Town/Organization: WILMINGTON

CATEGORY B/C/D

River Management Engineer Support Letter

Wilmington_Lake Raponda Rd_culvert upgrade

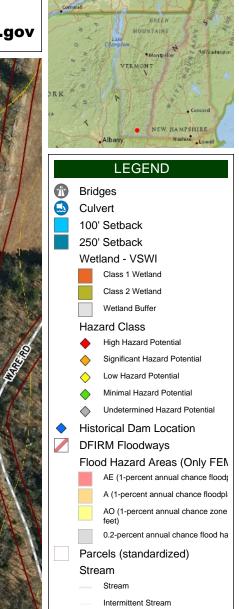
BASED ON FIELD INSPECTION BY RME ON 11/06/2023:

- * CHANNEL INLET CULVERT SIZED TO ACTIVE CHANNEL WIDTH FOR INTERMITTENT STREAM
- * ACW RANGE OF 2-3FT AND DRAINAGE AREA OF 20 ACRES, UTILIZE 30" CULVERT FOR CHANNEL
- * OUTLET APRON TO BE MINIMUM OF VTRANS TYPE II STONE FILL, SEE BETTER ROADS MANUAL
